Business Unit:	Electric	PI00000583
Product range:	Han Q3/4-M-C	Date: 2026/08/06
Author:	Svea Meier	Page 1/1
Title:	Han® Q 3/4 – Modified Coding Contour

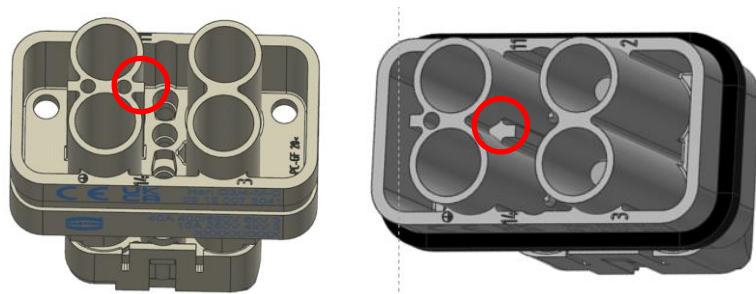
We would like to inform you about slightly modified of our Han® Q 3/4 insert. The coding contour of the Han® Q 3/4 male insert will be adjusted as to allow smooth mating.

Current mating face

New mating face with optimised contour

The coding contour of the Han® Q 3/4 male insert has been adjusted to provide improved alignment during connection. The improved inserts are fully compatible with the existing counterparts.

All technical characteristics according to the datasheet and the compatibility with former versions are unaffected. The modified inserts can be identified by a new revision level. First shipments of the revised Han® Q 3/4 male insert with the new contour are scheduled from October 2026 onwards. The revision levels will be raised by one as a distinguishing feature.
